S. S. "Stanley" Glasgow Report No. 8891.

Steel Screw Steamer. N 335

Profile

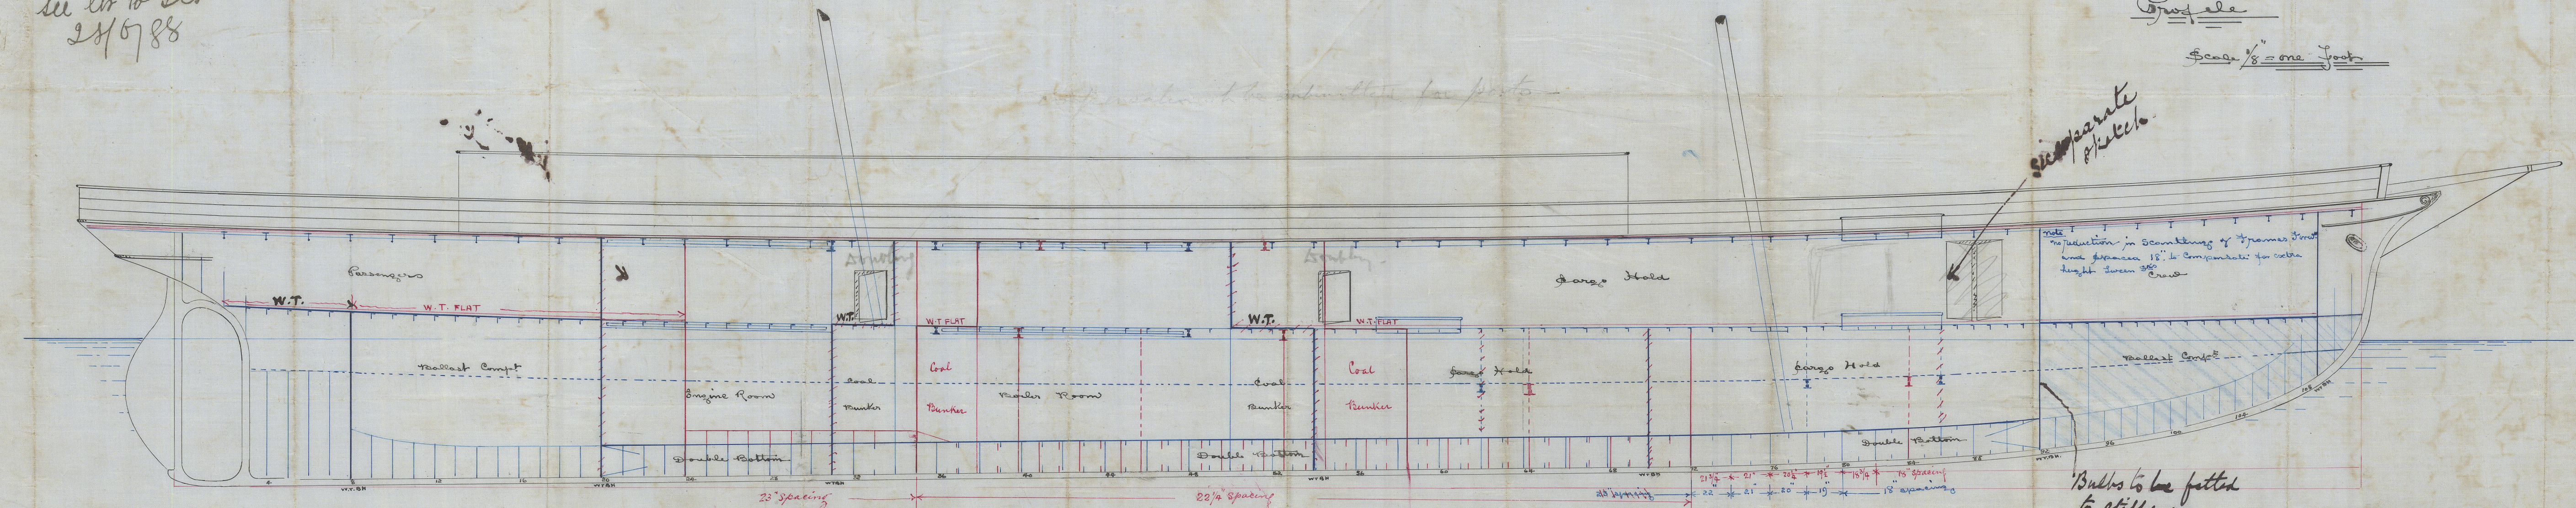
Note: Reduction in scantlings of frames fore and aft, and spaces 18" to compensate for extra height between 360 and 365

Bulbs to be fitted to stiffeners.
